HIGHLAND CITY DEVELOPMENT ADMINISTRATION BOARD AGENDA Wednesday, November 19, 2025

DEVELOPMENT ADMINISTRATION BOARD AGENDA REPORT ITEM #2

DATE: November 19, 2025
TO: Development Administration Board
FROM: Rob Patterson, City Attorney / Planning & Zoning Administrator
SUBJECT: **Final Plat Approval:** Tim Clawson Subdivision – Mountain View Acres Plat B Lot 26 Amended
TYPE: **LAND USE (ADMINISTRATIVE)**

FINAL REVIEW COMMENTS Clawson Subdivision

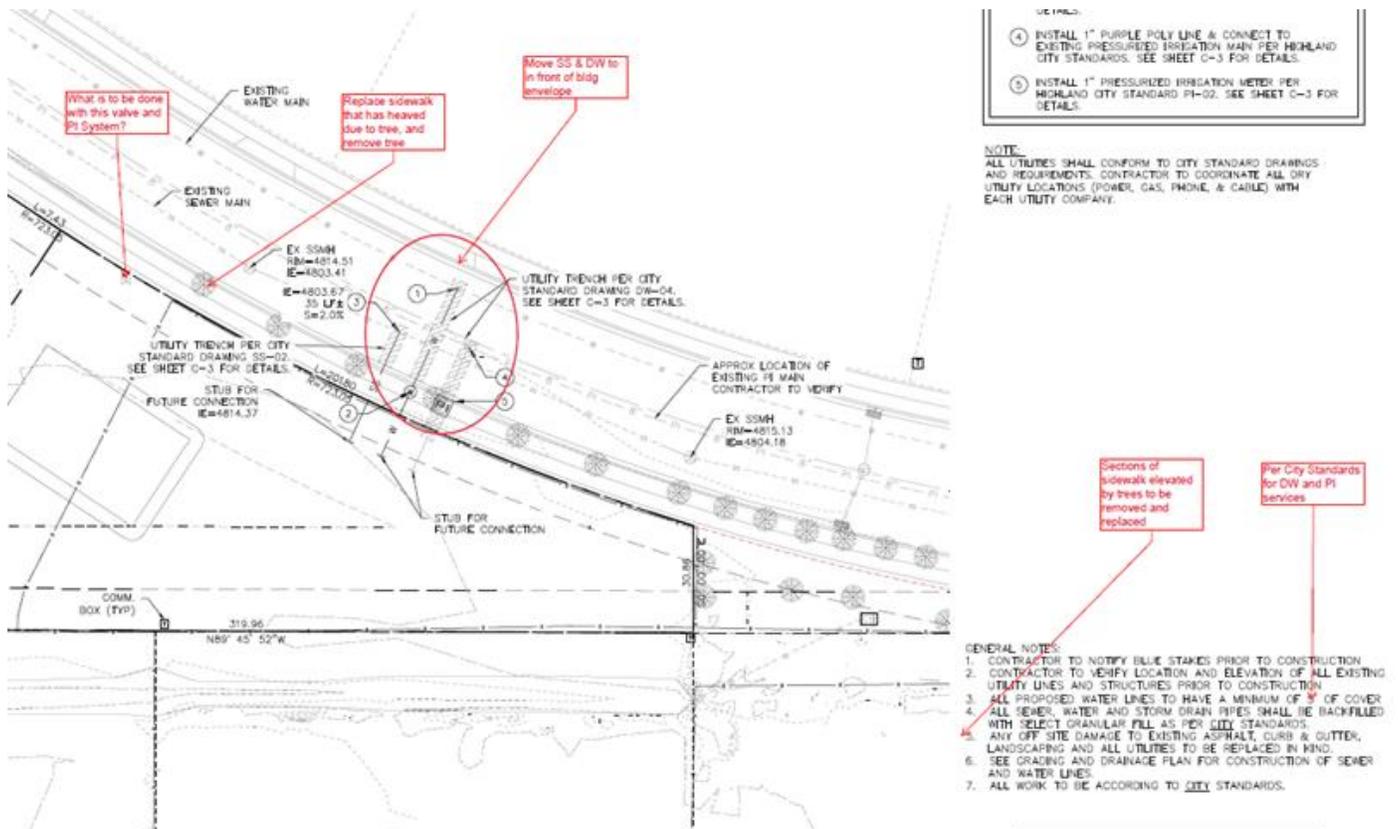
4. **C1 – Site Plan:** Move SS and DW services to be in front of future home to align with building envelope.
5. **C2 (Utility Plan):** PI Service:
 - a. Our notes indicate that the PI main is most likely on the north side of the road out of the asphalt according to the location of the valve on

6000 W. Please pothole and verify with our PI superintendent to identify exact location.

- b. There is a valve drawn in the plans on the south side of the road in the park strip area near the lot split. We are not aware of any valves in this location; it does not appear to be connected to anything. Remove or clarify.

**MOUNTAIN VIEW ACRES
PLAT "B" LOT 26 AMENDED**
LOCATED IN THE NORTHWEST QUARTER OF SECTION 2
TOWNSHIP 5 SOUTH, RANGE 1 EAST
SALT LAKE BASE AND MERIDIAN
HIGHLAND CITY, UTAH COUNTY, UTAH

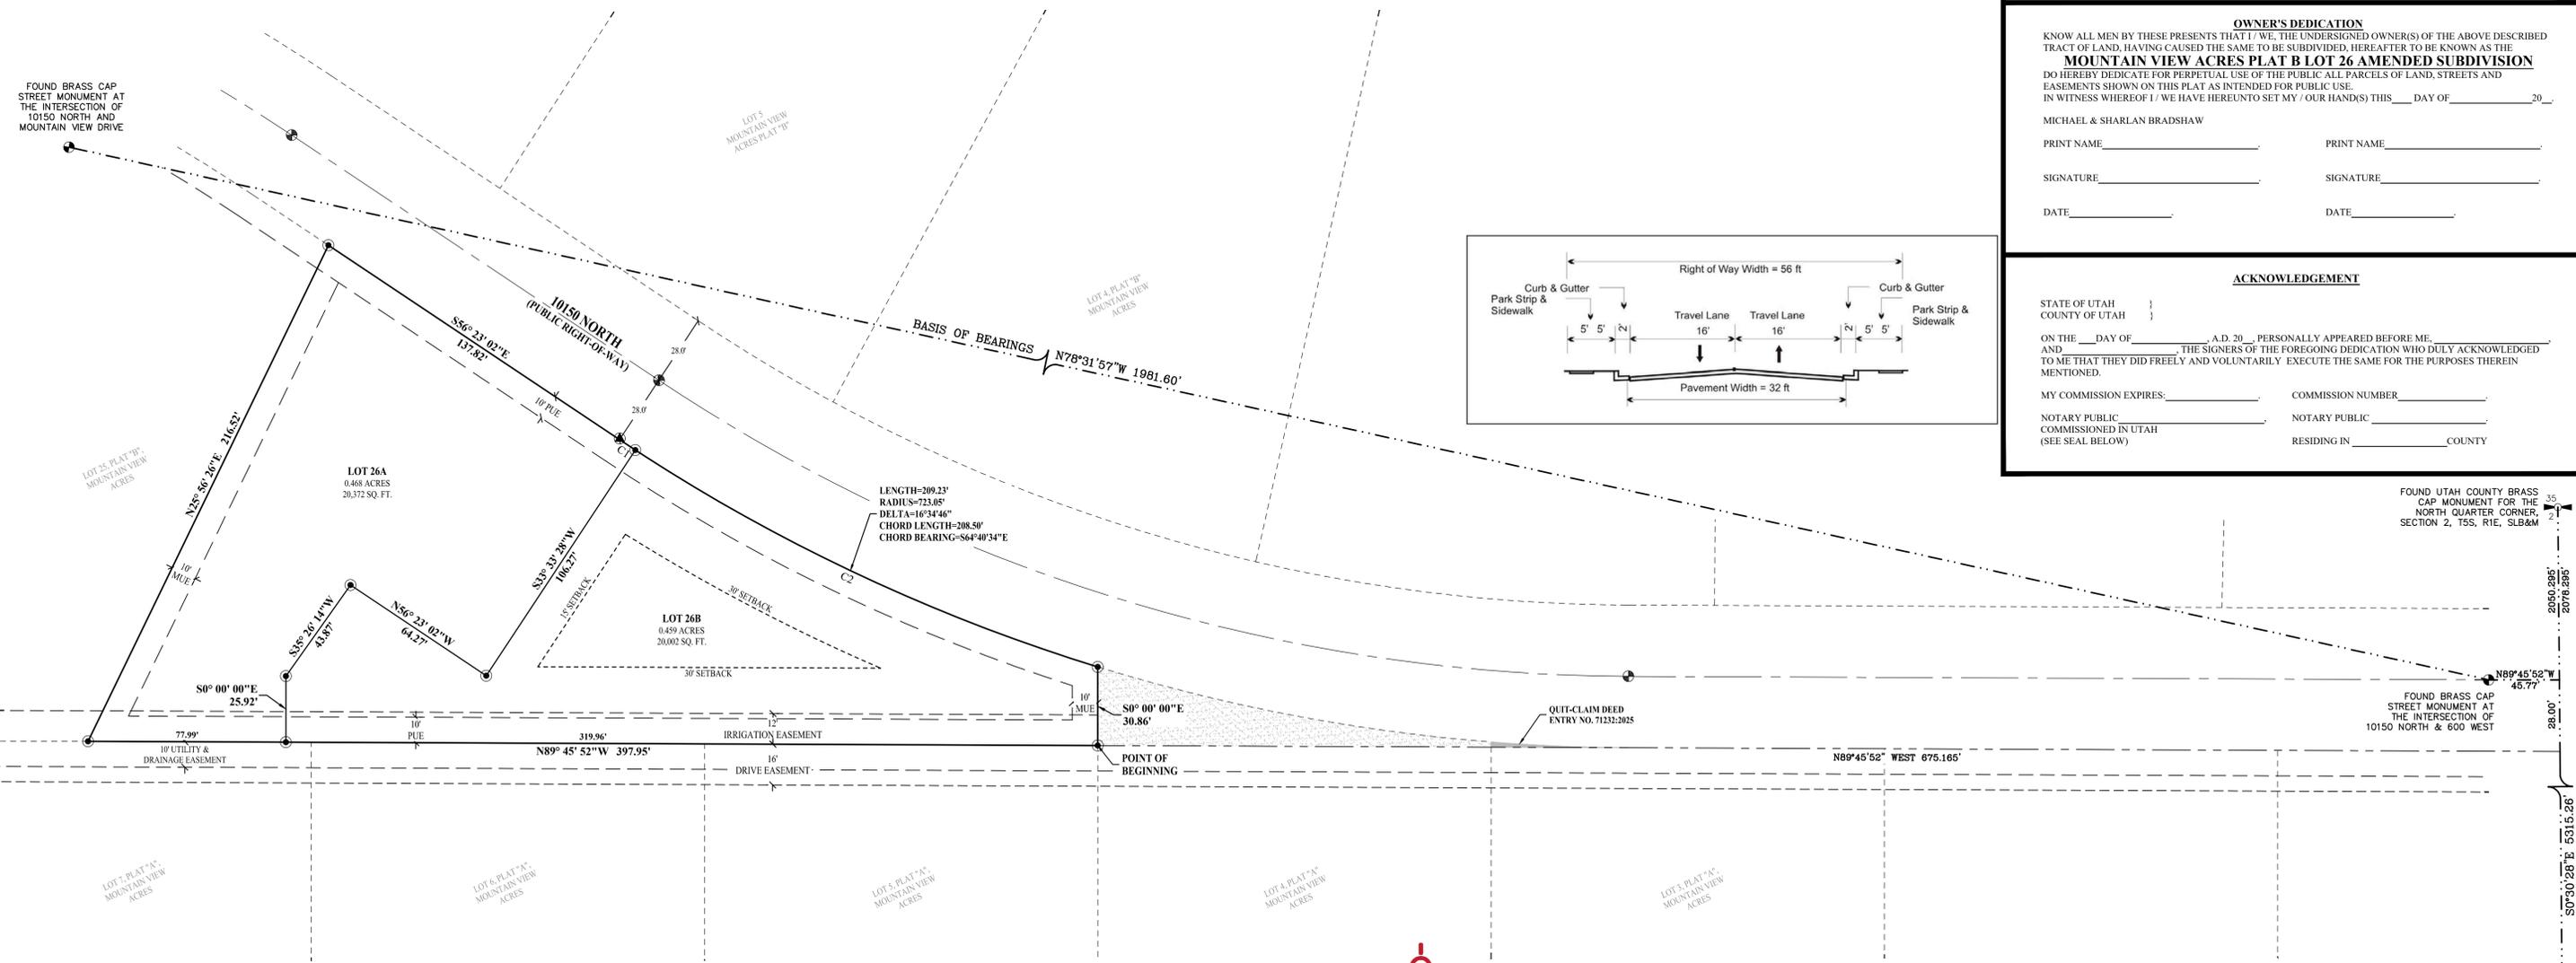
1. **Plat:** Label ROW diagram as 10150 N.
2. **Plat:** Provide addresses for each lot. Maintain current property address for western lot/existing home.
3. **C1 – Site Plan:** Curb, gutter and sidewalk along entire frontage must meet current Highland City Standards and be in good working order. Replace any improvement not in working order, no matter the cause (see photo). Please provide callouts to remove tree and damaged sidewalk and replace sidewalk. This comment is typical in any location along the frontage of both properties.

TIM CLAWSON SUBDIVISION
UTILITY PLAN
6131 W 10150 N, HIGHLAND, UT, 84003

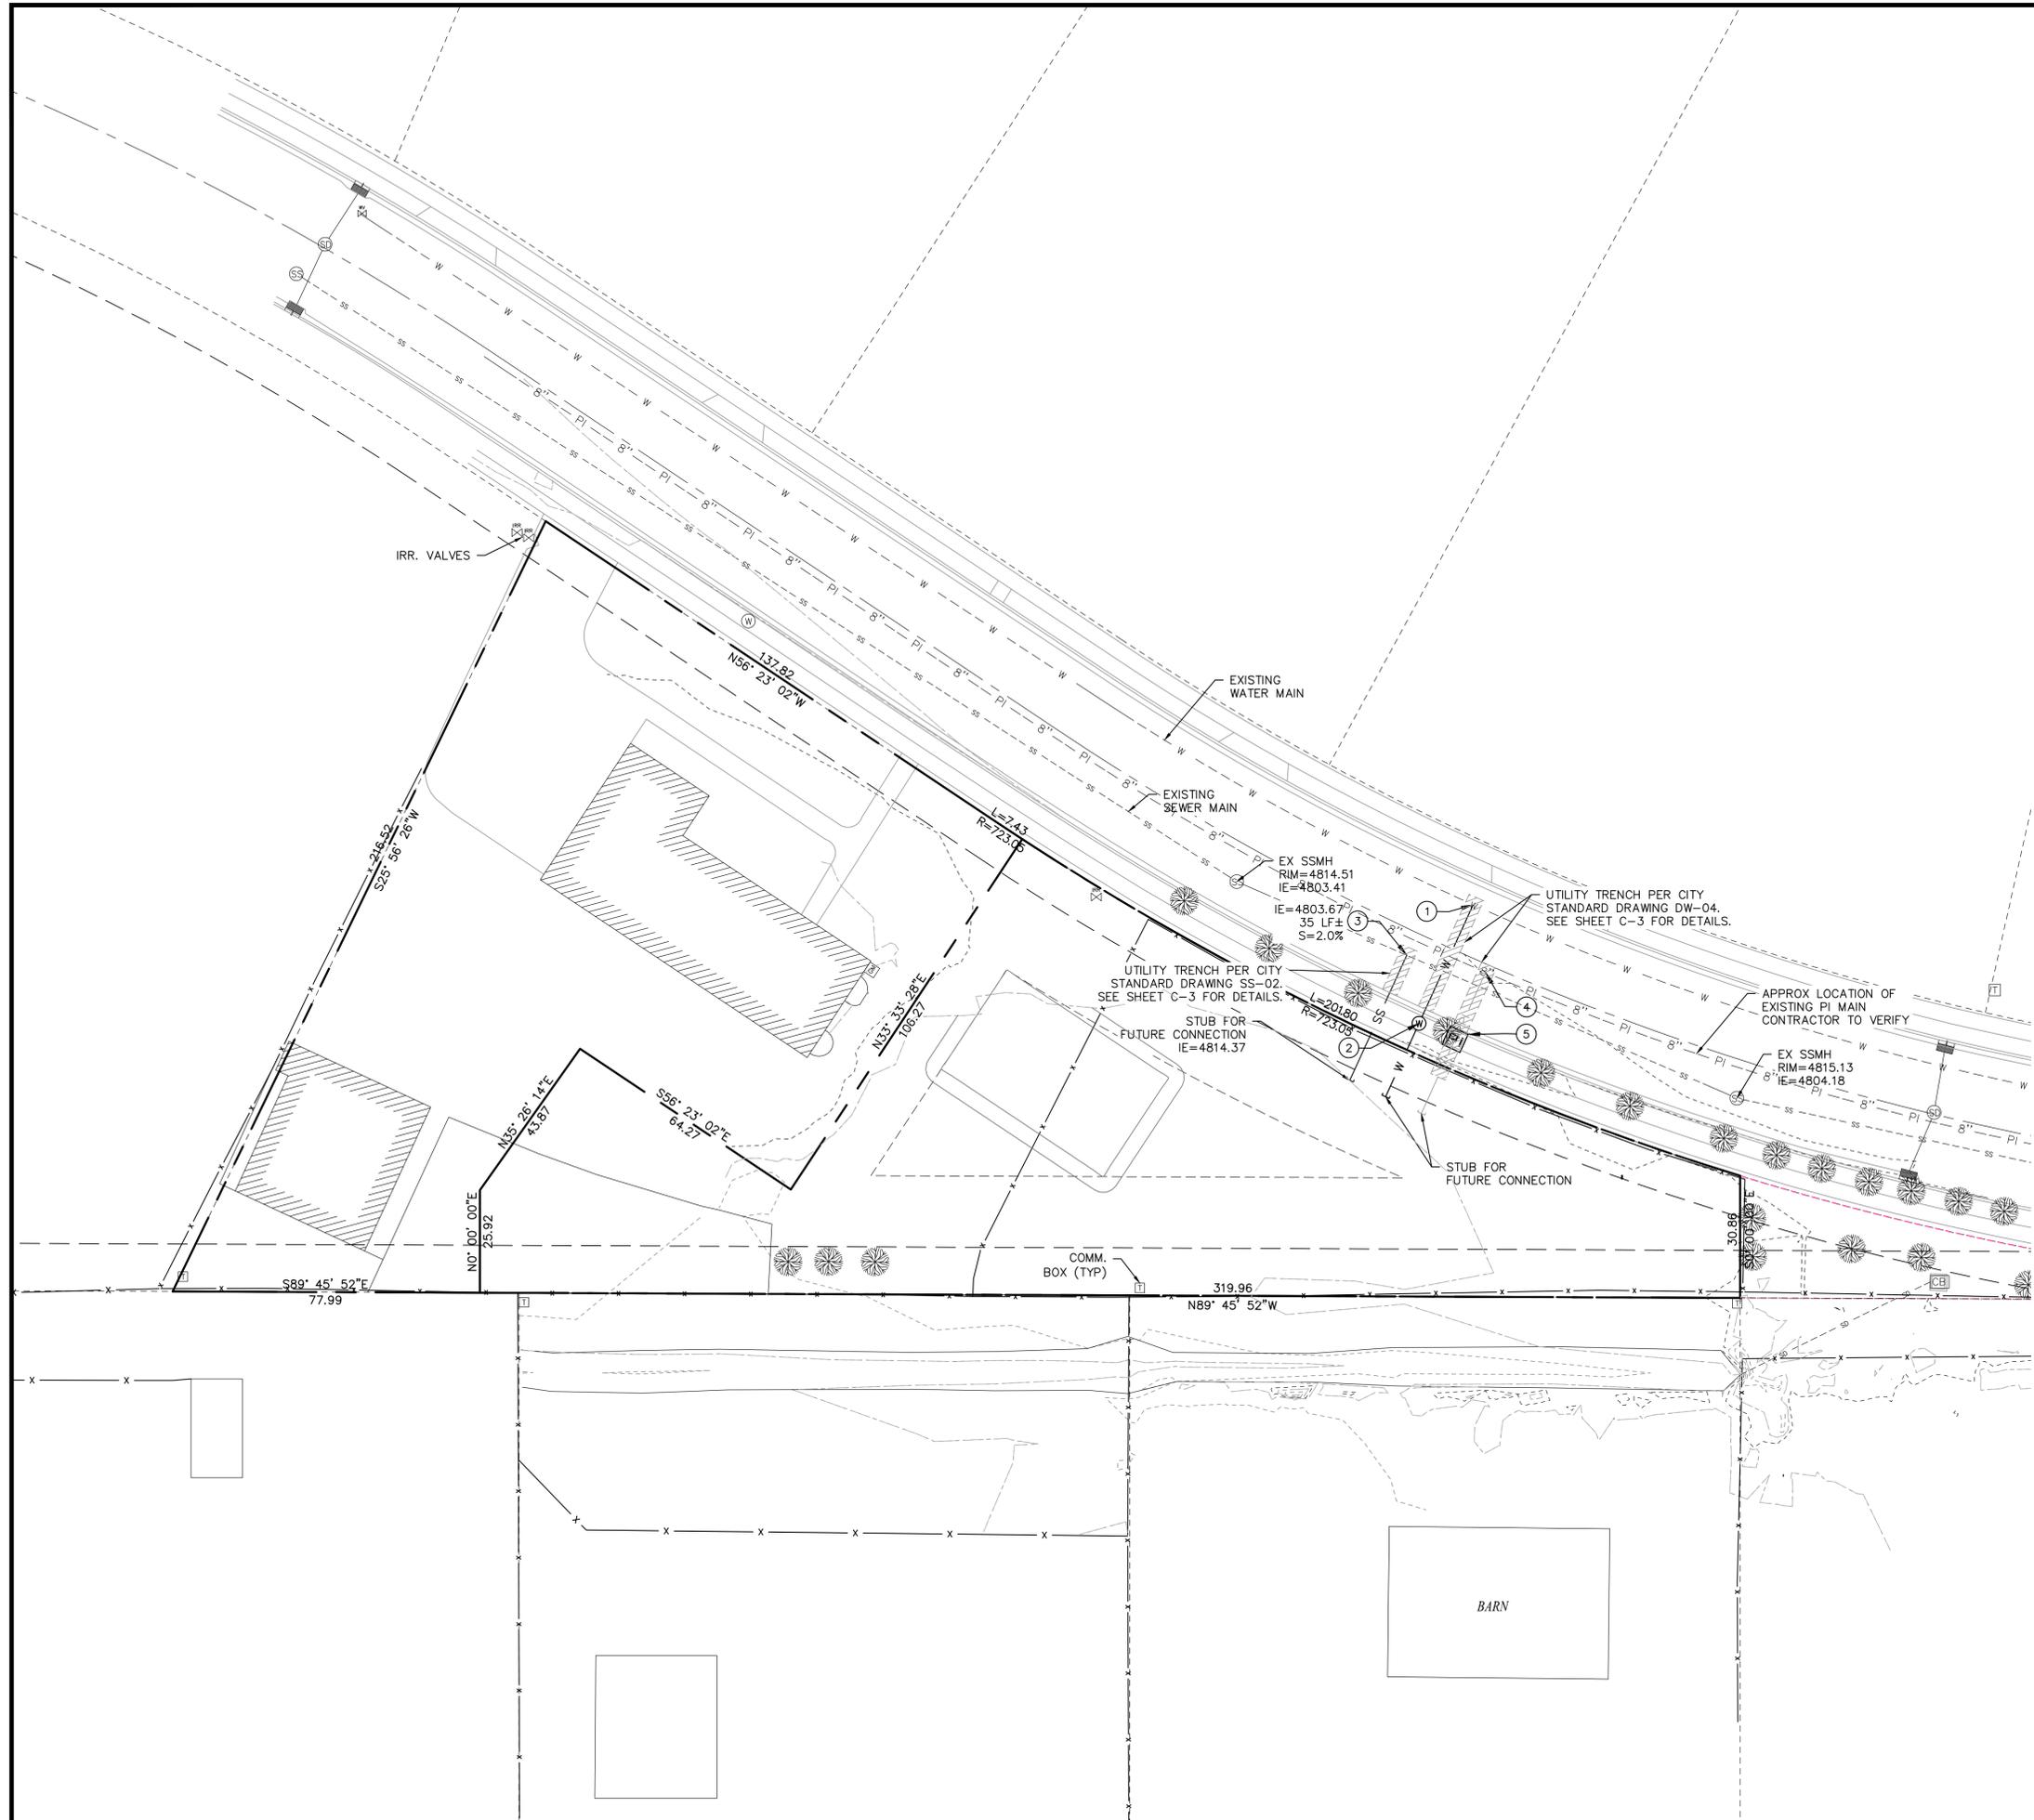
6. **C2 (Utility Plan):** Note 3 references to 5' minimum bury depth for water lines, it should refer to the City Standards.

7. **C2 (Utility Plan):** Add a comment to sheet C-2 to protect to protect in place the existing irrigation ditch and any appurtenant structures on the back lot line.
